1985
EDDY CURRENT EXAMINATION MANUAL FOR
HOUSTON LIGHTING AND POWER COMPANY

South Texas Project
Unit 1

IE Document No.: 85-030

HL&P Comments on
BAW Drawing 1157654A
"Cal. Standard"

FIGURE 1 - TUBE SUPPORT PLATE LOCATION AND NUMBERING SEQUENCE FOR E2
RSG's.

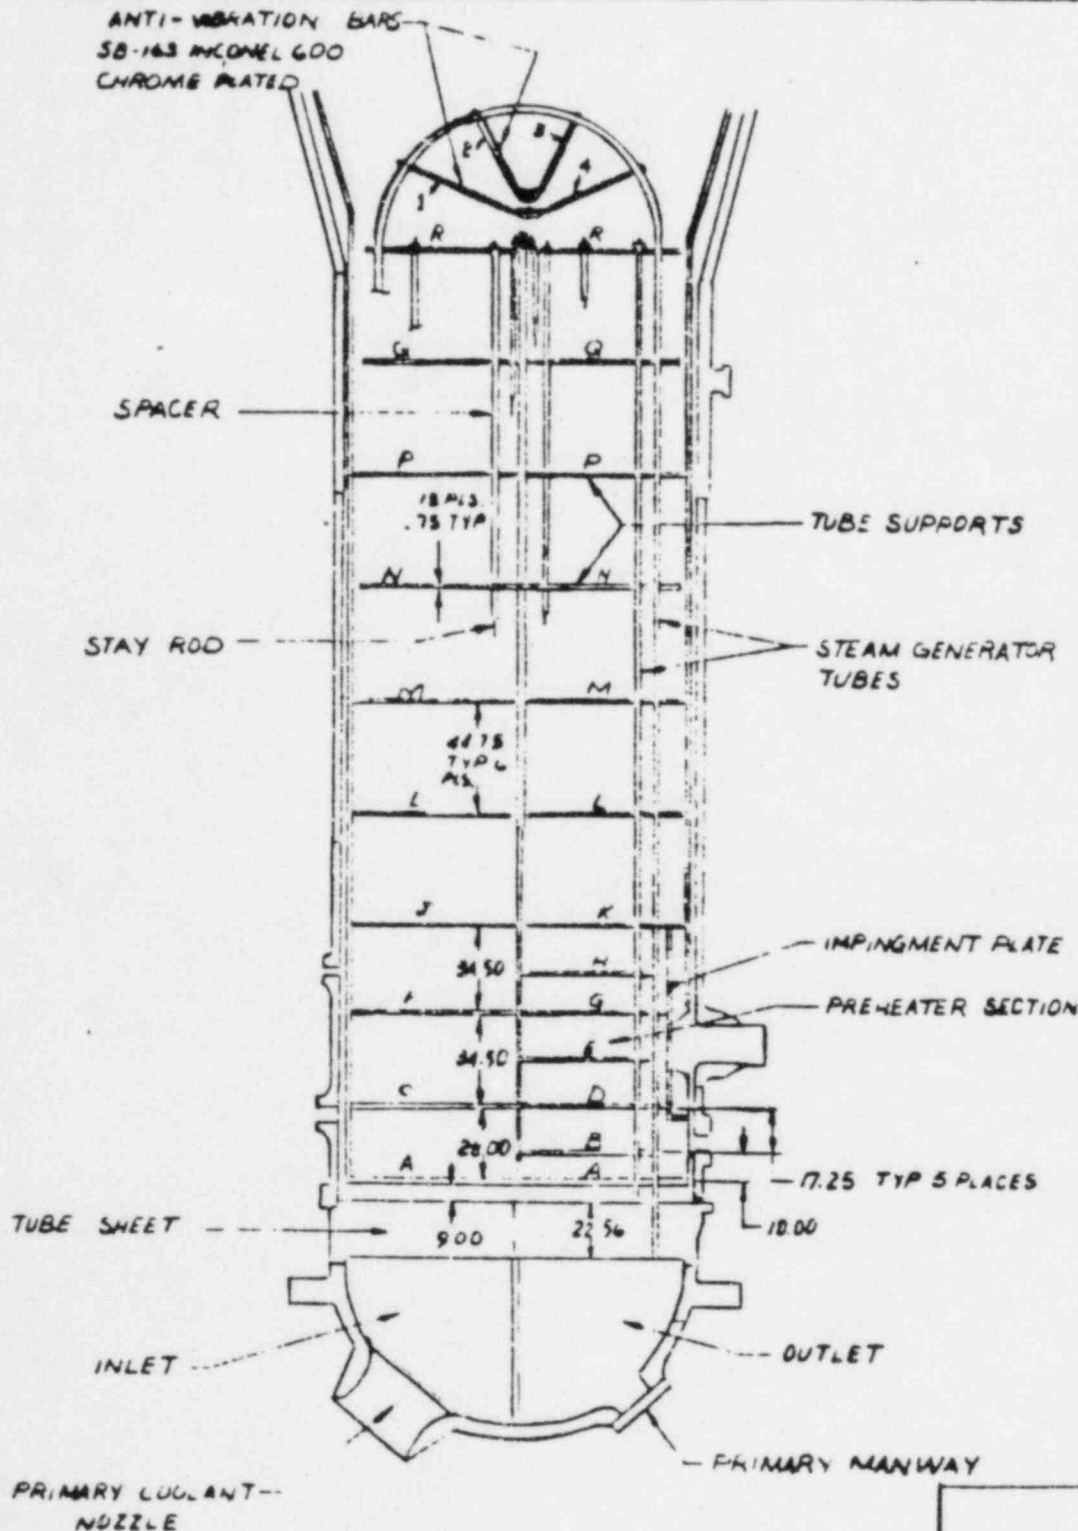
| 4 | Figure 1 should be Included before use. |

FIGURE 3 - MIZ-18 EQUIPMENT INTERCONNECTIONS

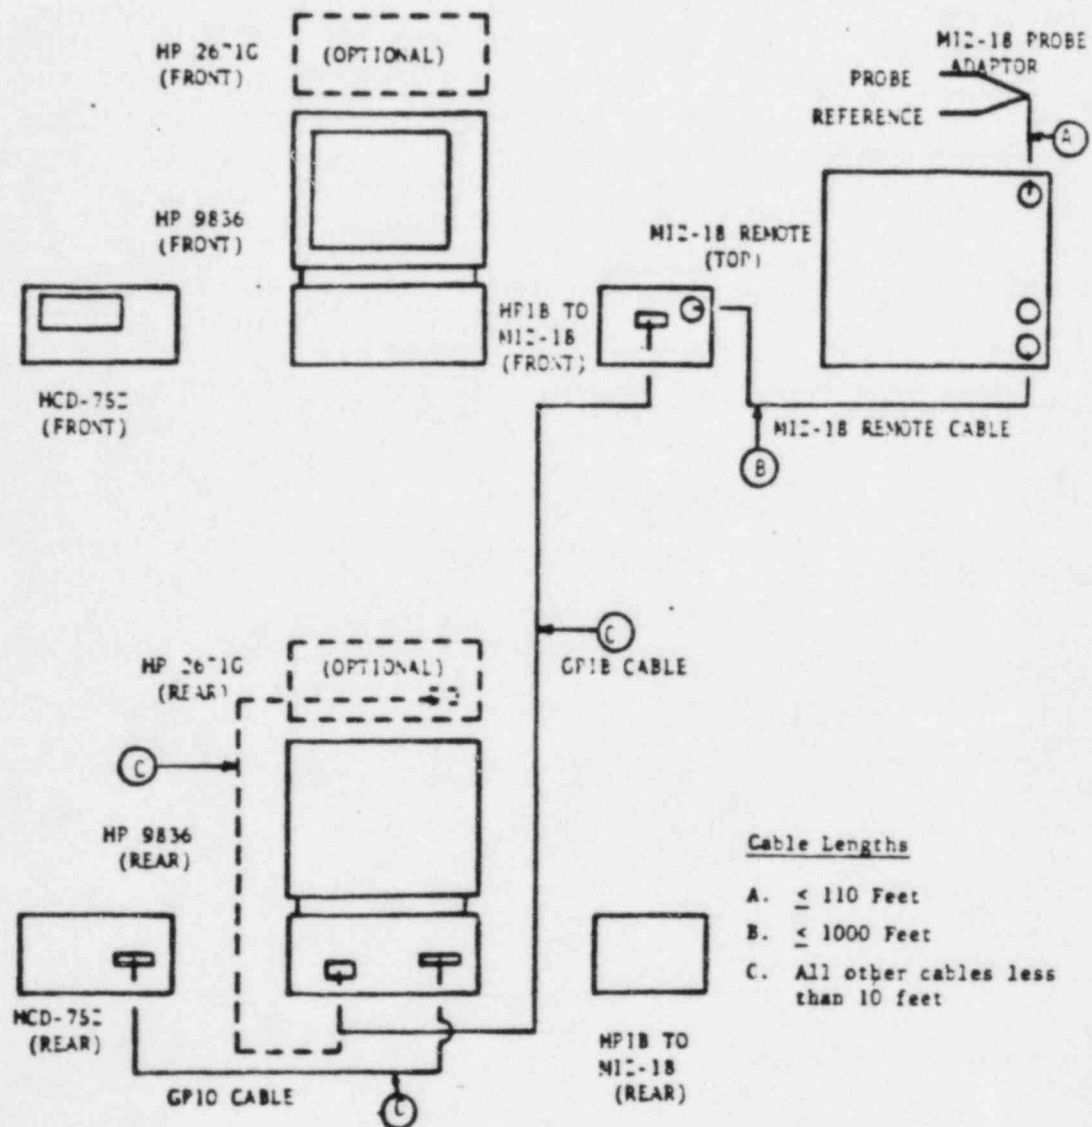
| 3 | In Paragraph 4.6.3, "Figure 1" should be "Figure 3". |

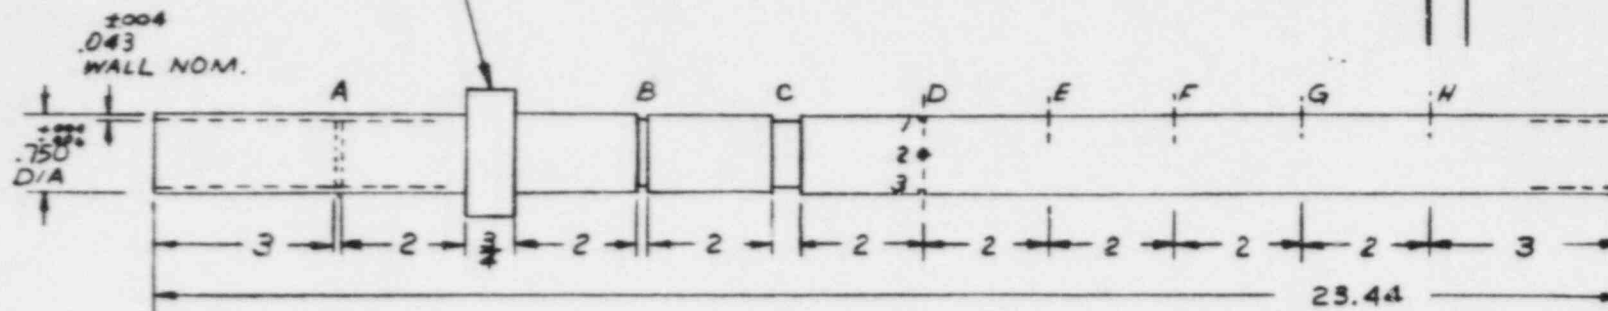
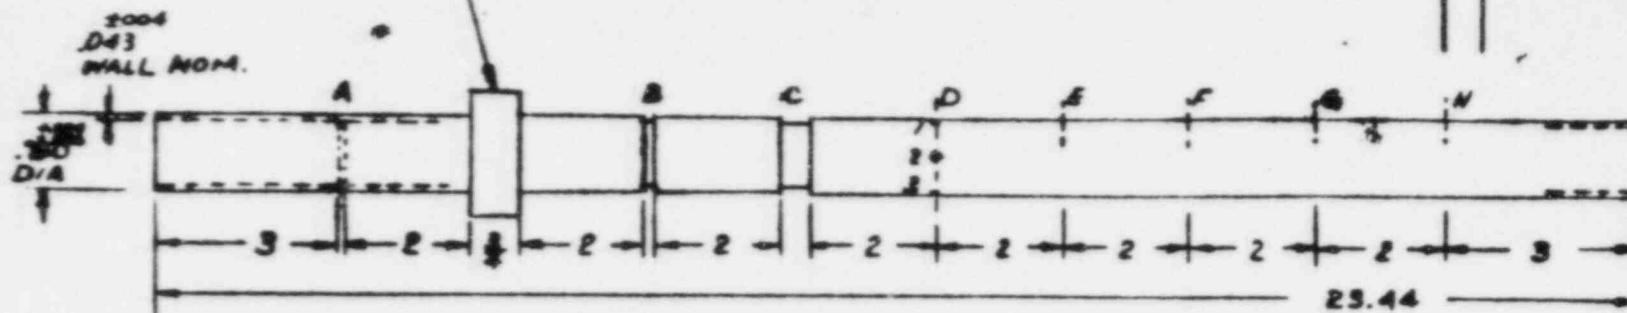
| 4 | The drawing must be approved and issued final
